**Pro-L1490U/ L1495U / L1500UH / L1505UH / L1715SNL / L1750UNL /  
L1755UNL**

**Firmware v3.01 Release notes**

2. Updating information (Previous version: V2.23 -> New version: V3.01)

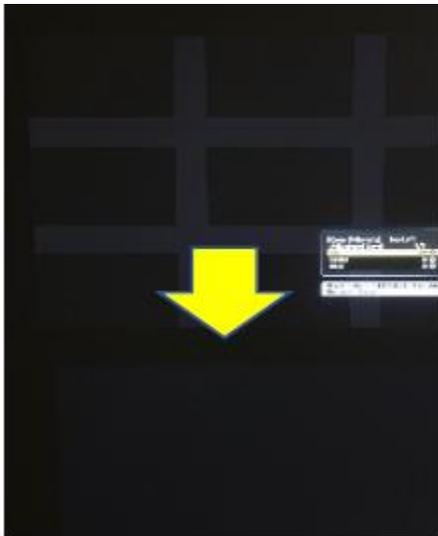
4. Improved geometric correction (Quick corner/Curved surface/Corner/Point correction) so that correction points can be set on the outside of the projection area.

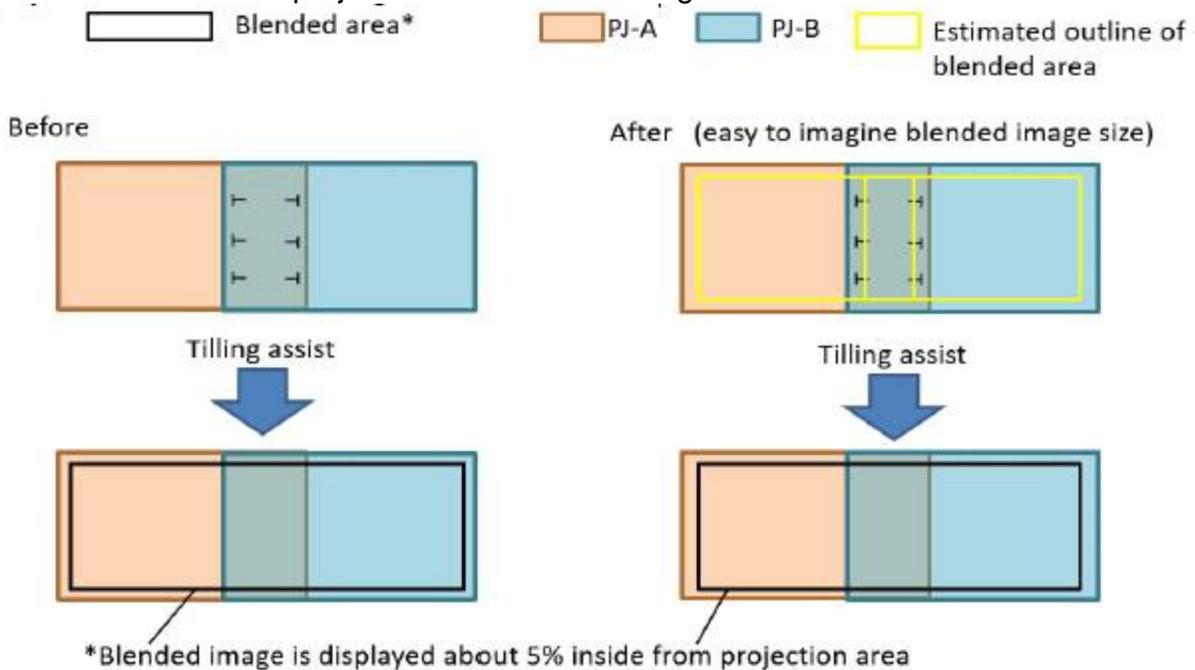
25. Fade-in / fade-out function is changed as follows

- Before change: only image processing
- After change: image processing + light source brightness control

Improvements to fade-in/out function. Improvements have been made by adding light source brightness control.

- Brightness is noticeable when black image is displayed in dark room at the timing of fade-in/out.
- Fade-in/out processing is not smooth

\*Menu: Extended -> Operation -> Auto Source Search

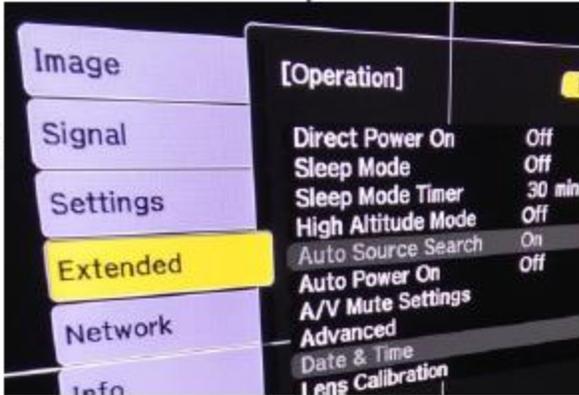
28. While displaying test pattern, Auto Source Search menu is grayed out.

In current specification, if the Auto Source Search setting is changed while displaying the test pattern, the changes will not be reflected until test-pattern is canceled.

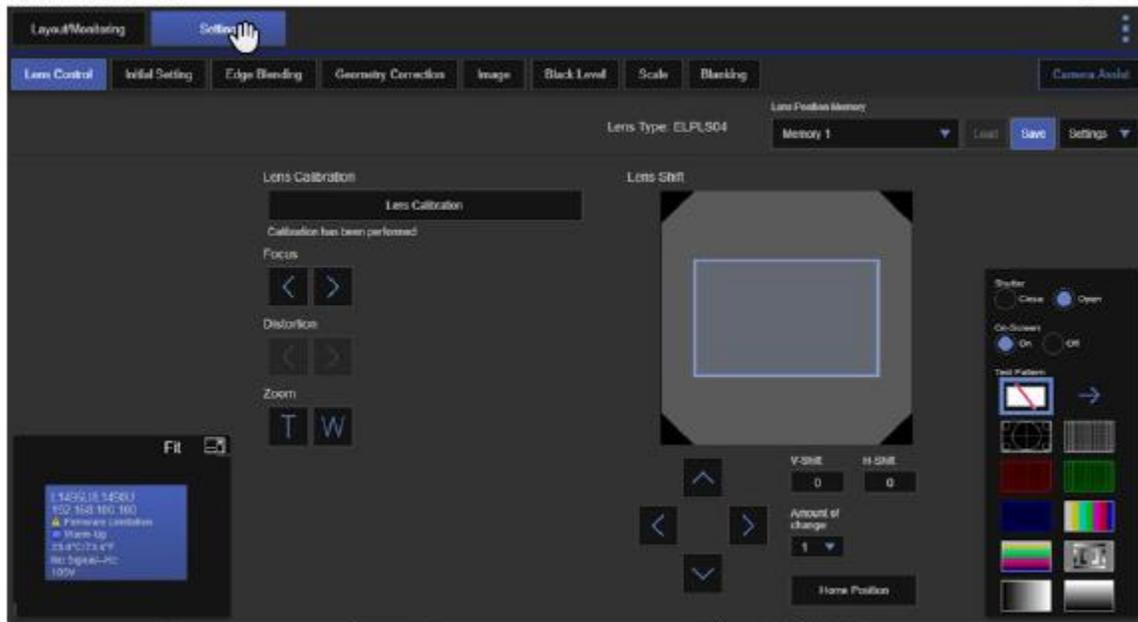
31. (Multi-projection function) Changed the color and size of the black level adjustment window when:

"Color adjustment" is selected under the black level adjustment menu\*

Black level adjustment window is too bright which affects the adjustment of the black level around the window.

(Settings -> Brightness Settings)

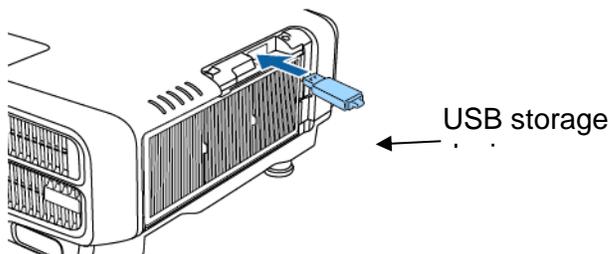
13. Higher limit of brightness level and that factor are displayed in “Brightness Settings” menu under the following conditions.

- (1) Install a lens in a projector that does not support maximum brightness of the projector
- (2) Brightness locking function is set to “on”
